Date: March 8, 2010  
To: All Bidders of Record  
Re: "Airfield Lighting Rehabilitation" Project  
Rock Hill/York County Airport (TBI #3709-0901)

**ADDENDUM NO. THREE (3)  
TO  
AIRFIELD LIGHTING REHABILITATION  
ROCK HILL/YORK COUNTY AIRPORT  
ROCK HILL, SOUTH CAROLINA  
TBI PROJECT NO. 3709-0901**

**March 8, 2010**

**L-858 GUIDANCE SIGN DETAIL**

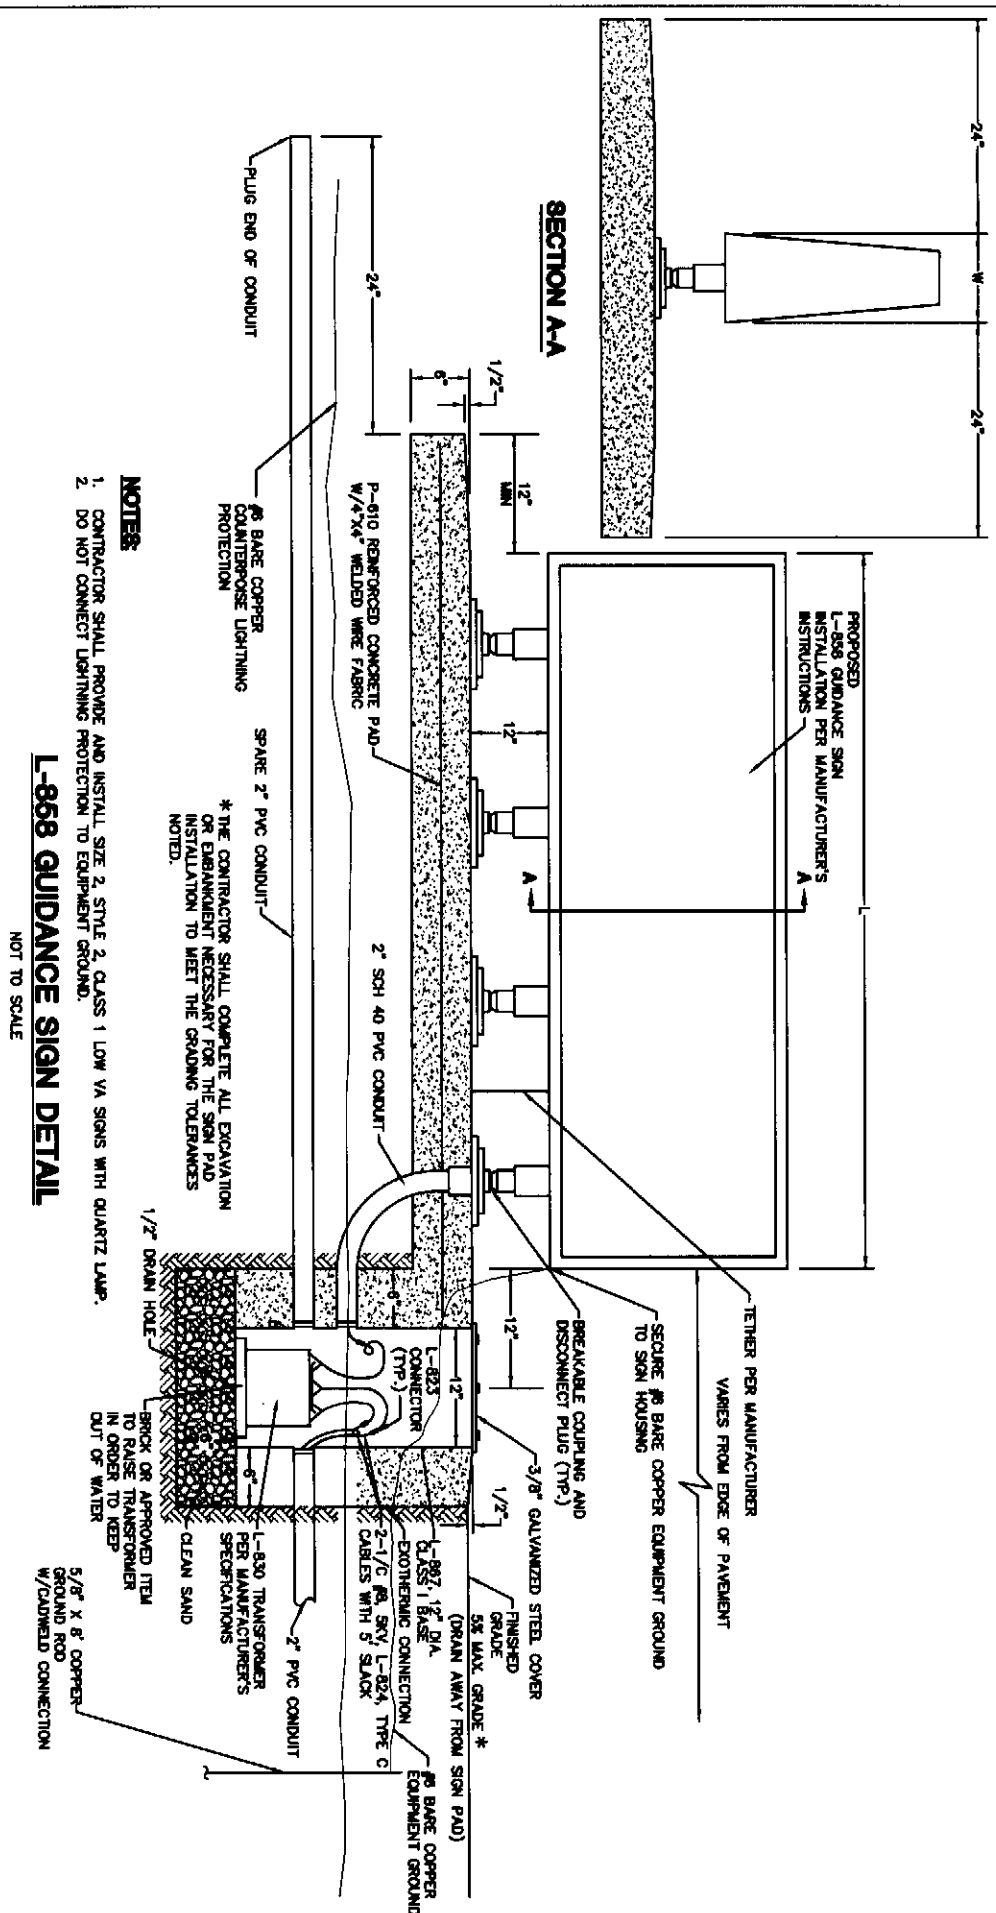
2. **ADD** the "L-858 GUIDANCE SIGN DETAIL" of Addendum No. Three (3) to "ELECTRICAL DETAILS (SHEET 1 OF 2)."

- NOTES:**
1. CONTRACTOR SHALL PROVIDE AND INSTALL SIZE 2, STYLE 2, CLASS 1 LOW VOLT SIGNS WITH QUARTZ LAMP.
  2. DO NOT CONNECT LIGHTNING PROTECTION TO EQUIPMENT GROUND.
